VIRGINIA ELECTRIC AND POWER COMPANY (DOMINION)
NORTH ANNA POWER STATION UNITS 1 AND 2
PROPOSED IMPROVED TECHNICAL SPECIFICATIONS
REQUEST FOR ADDITIONAL INFORMATION (RAI)
SECTION 3.6 (TAC NOS. MB0799 AND MB0800)
MISCELLANEOUS DOMINION CHANGES TO ITS SUBMITTAL

**Proposed Improved Technical Specifications
Responses to Requests for Additional Information
ITS 3.6, "Containment Systems"**

North Anna Power Station Units 1 and 2

Figure 3.4.3-1 (page 1 of 1)
Unit 1 RCS Heatup Limitations
Heatup Rates up to 60°F/hr, Applicable for the first 32.3 EFPY,
Including Margins for Instrumentation Errors

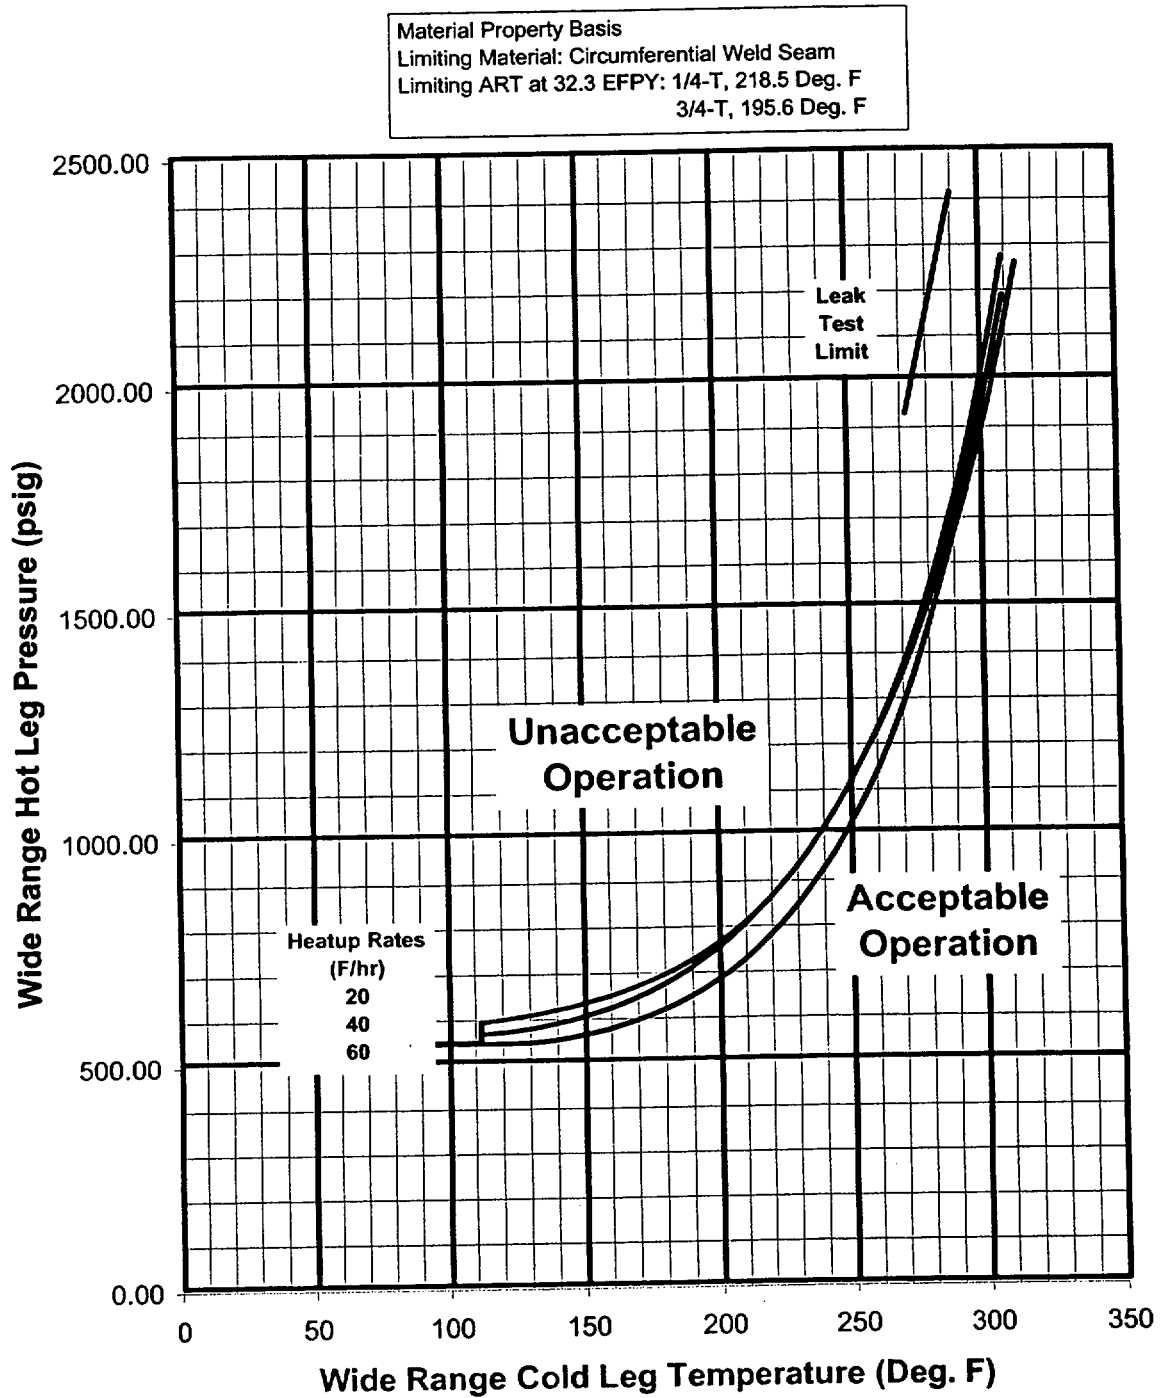
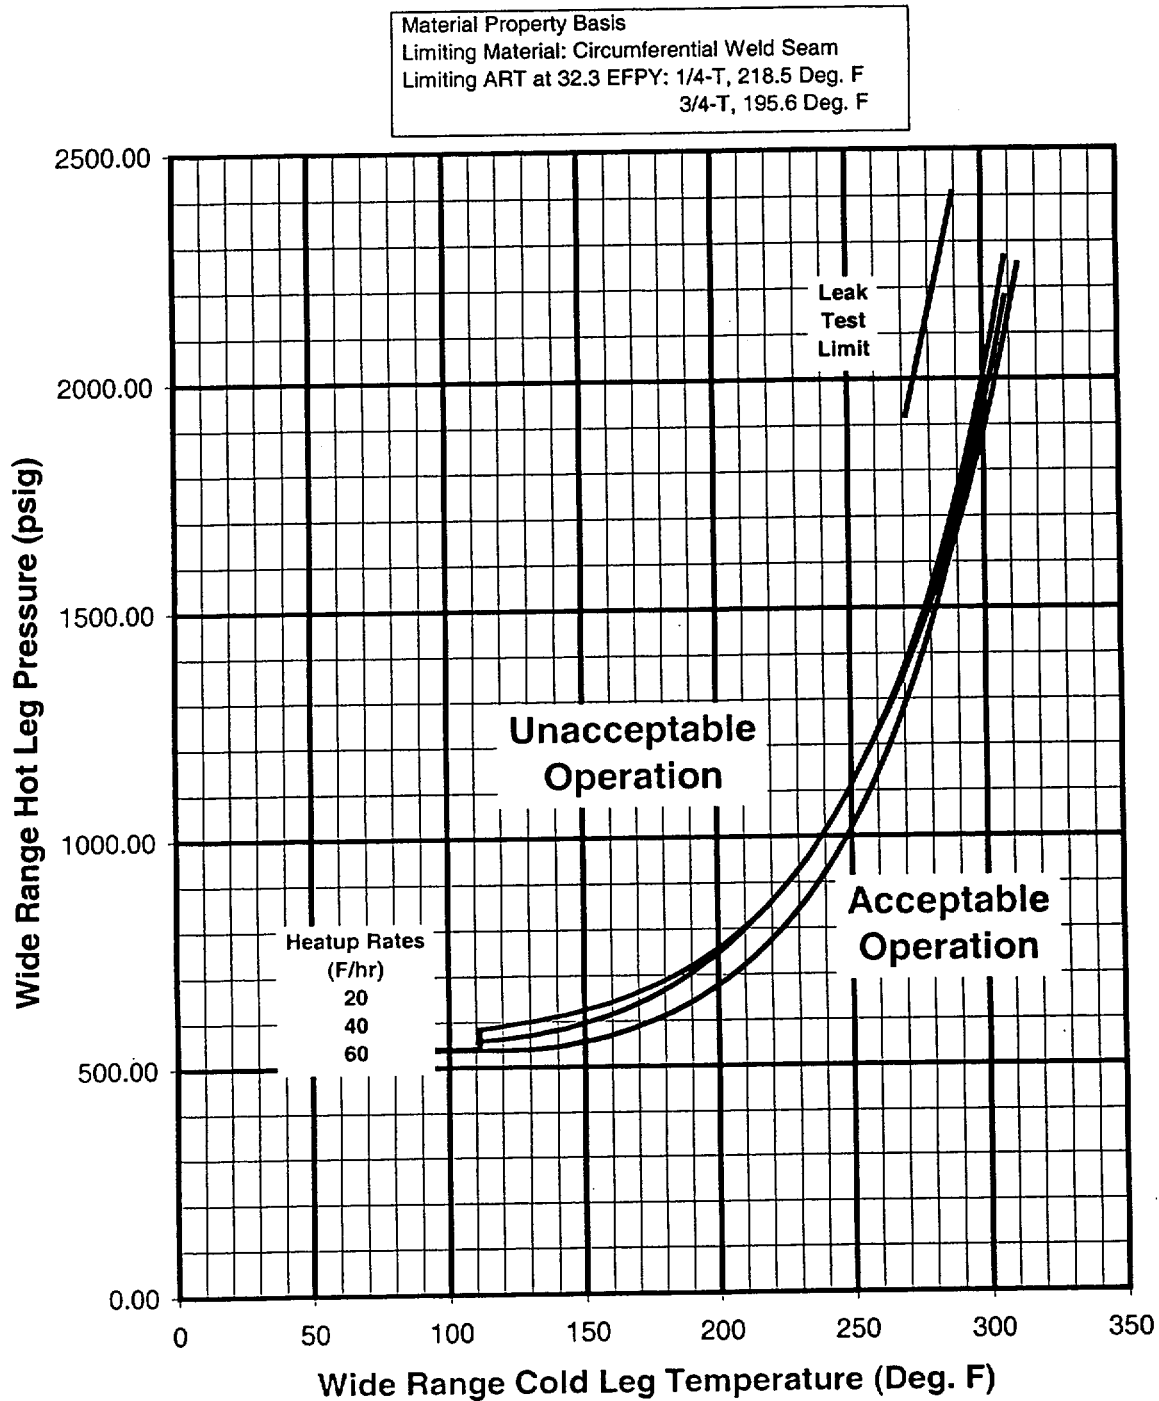
North Anna license amendment 226 (Unit 1) and 207 (Unit 2), dated May 2, 2001, revised the Unit 1 and Unit 2 heatup and cooldown curves. The revised curves are incorporated into the typed ITS, the ISTS markup, and the CTS markup.

Material Property Basis
Limiting Material: Circumferential Weld Seam
Limiting ART at 32.3 EFPY: 1/4-T, 218.5 Deg. F
3/4-T, 195.6 Deg. F
